Questions & Answers

Title:	N2 Display reading				
					0159
Date in:		Response:	Model:	Author:	
2006-03-02		2006-03-02	-	СМа

StX 40/200

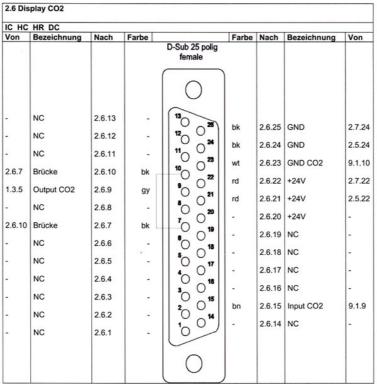
N2-display reads 77.3%. The controller returns 0.

To set: WR DM895 9000 -> seta N2 to 90%

To read: RD DM985

The data output on the display is on pin 9. Pin 7 and 10 must be bridged. On the 37-pin D-SUB connector on the Module the data line for N2 is 1.3.6 (I think). Anyway, there should be connection between 2.6.9 Pin 9 of the connector at the N2 display and input 009 on the PLC. And 009 should be blinking indicating rx data.
